Subject: Response to the Referenced Information Request, Waste Isolation Pilot Plant
 Hazardous Waste Facility Permit Number: NM4890139088-TSDF

Reference: New Mexico Environment Department Correspondence from John E. Kieling, Chief, Hazardous Waste Bureau to Todd Shrader, Carlsbad Field Office and Bruce C. Covert, Nuclear Waste Partnership LLC, dated January 25, 2019, subject: Information Request, Determination of Class for New Shaft and Associated Connecting Drifts Waste Isolation Pilot Plant EPA I.D. Number NM4890139088

Response to NMED Information Request, Determination of Class for a Permit Modification Request for the Excavation of a New Shaft and Associated Connecting Drifts

Figure 1: Design Drawing of S#5

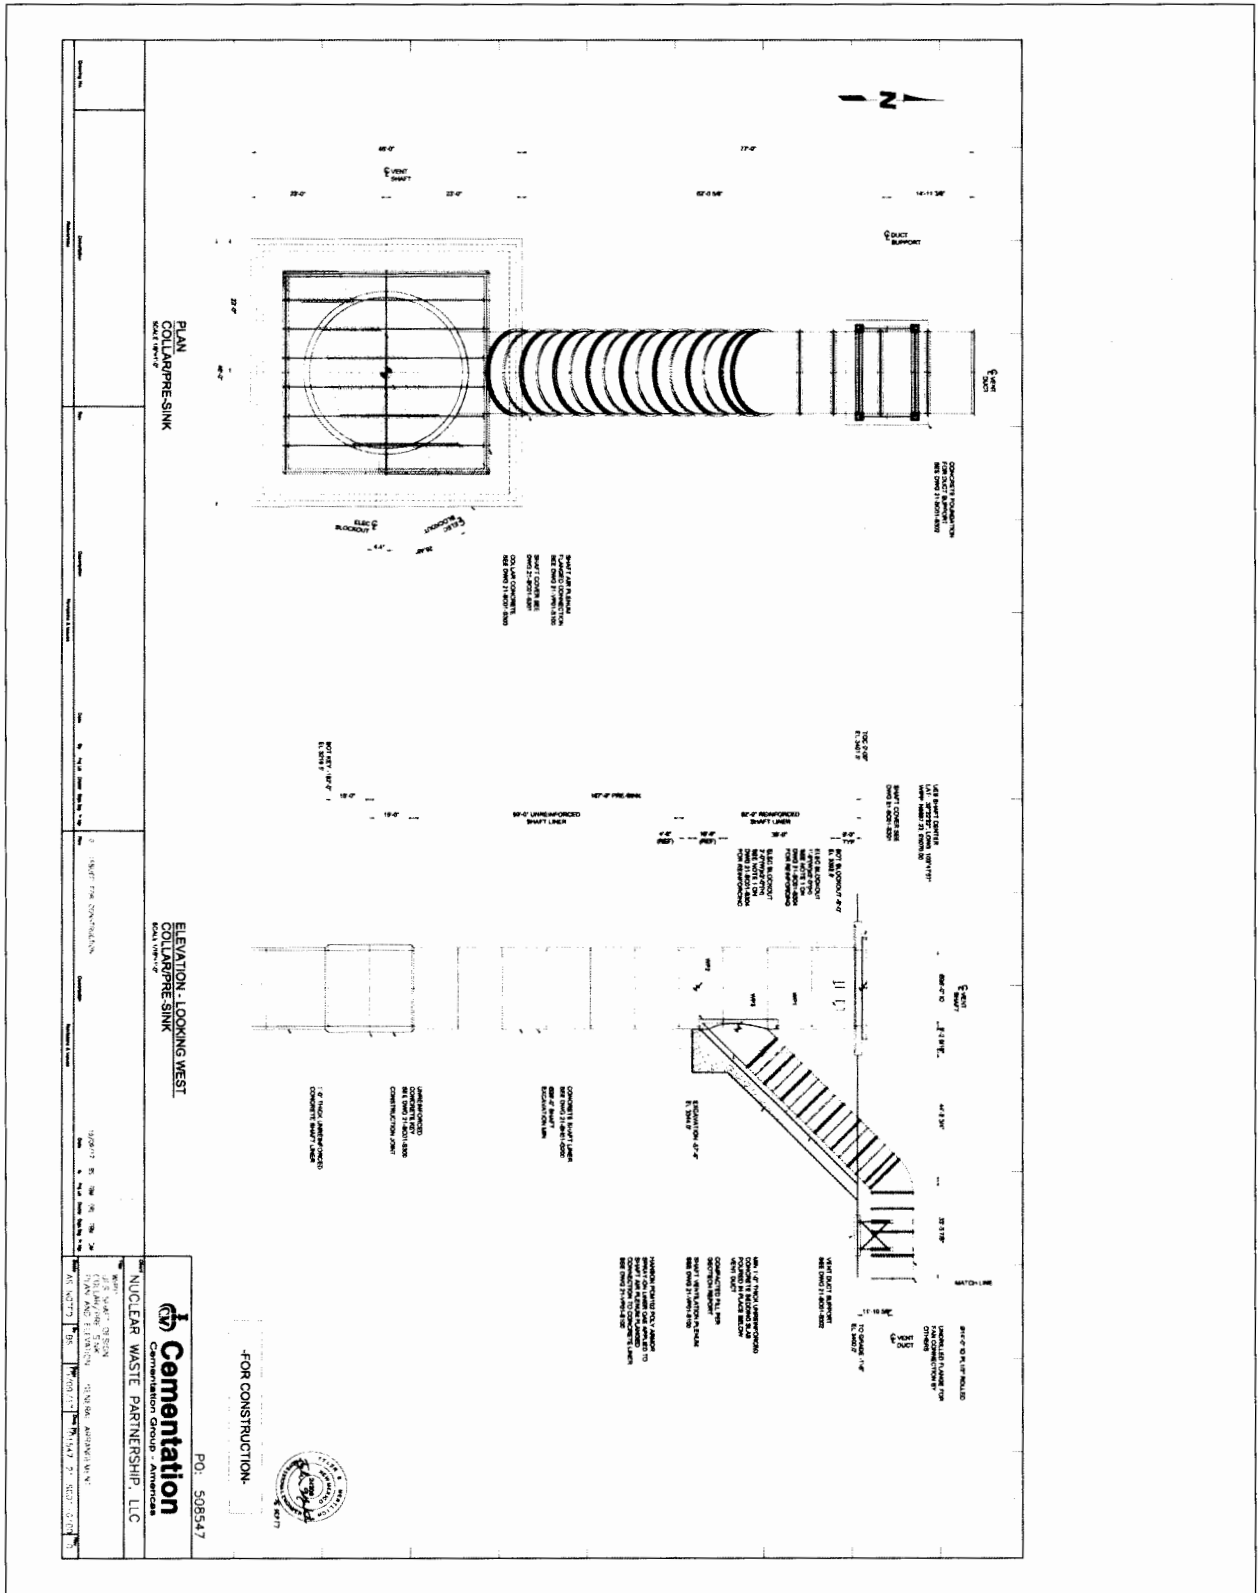
Identify whether a hoist is planned for the proposed new shaft as part of the project. If this is the case, state why a description of a hoist is not included in the Class Determination.

The new S#5 will be an enclosed shaft. The collar of the shaft will be covered with a steel cover. Surface fans (intake fans) will be connected to S#5 via duct from the fan to an intersection point in the shaft that is approximately 30-50 feet below the surface

(See Figure 1). The intake fans will push air into the UG while the steel cover over the collar will ensure that the air is directed into the UG. Two fans will be connected to the shaft. One fan will operate while the other fan will be used as a back-up. The fans will have VFD controllers. The VFDs will be programmed to respond to the flow from the exhaust fans. As an example, if one exhaust fan were to suddenly break down, total exhaust at the ES would be reduced. The reduced flow rate would be communicated to the intake fan at S#5. The VFD would slow down the intake fan to a desired pre-programmed intake airflow rate to prevent the intake fan from over-pressuring the UG. This type of automatic integrated control of both the intake and exhaust flow for the UG is a technological advancement for the operation of the ventilation system at the WIPP facility for the following reasons:

A permanent hoist is not part of the current design or budget for the Utility Shaft project, but it is not precluded as a future design change when the need develops (e.g., to hoist salt from mining additional disposal areas). A design drawing of S#5 showing a side view with the ventilation duct extending to the surface is included as Figure 1. Figure 1 shows that the collar of the shaft is capped with a steel cover which prevents the installation and operation of a hoist. A temporary hoist will be installed over the shaft to allow for excavation (salt removal) of S#5 and the associated drifts. The temporary hoist will be removed once it is no longer needed for the construction phase of the project. When design changes are proposed to S#5 in the future as part of future repository configurations, the appropriate regulatory process will be followed to initiate applicable changes to the Permit. However, specific future repository configurations are beyond the scope of this modification.

An illustration showing a side view of S#5 along with the ventilation duct from the shaft to the fans is attached as Figure 1.
